31 March 2014

**Determination Report
Sydney University Abercrombie Precinct Redevelopment (MOD 3)**

Figure 1: Draft sketch submitted by the proponent

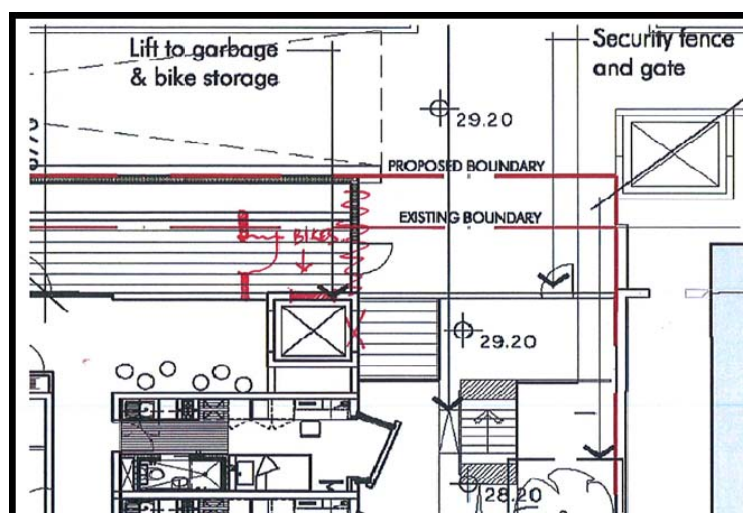
Mandelbaum House requested that the lift opening face away from Mandelbaum House to minimise noise and amenity impacts on its residents. The Commission requested the proponent to reconsider the lift opening at ground level. In response the proponent advised that it would re-direct the opening to the north as shown in the plan below. An amended plan to reflect the change shall be submitted to the satisfaction of the PCA. A condition is imposed accordingly (Condition B31).
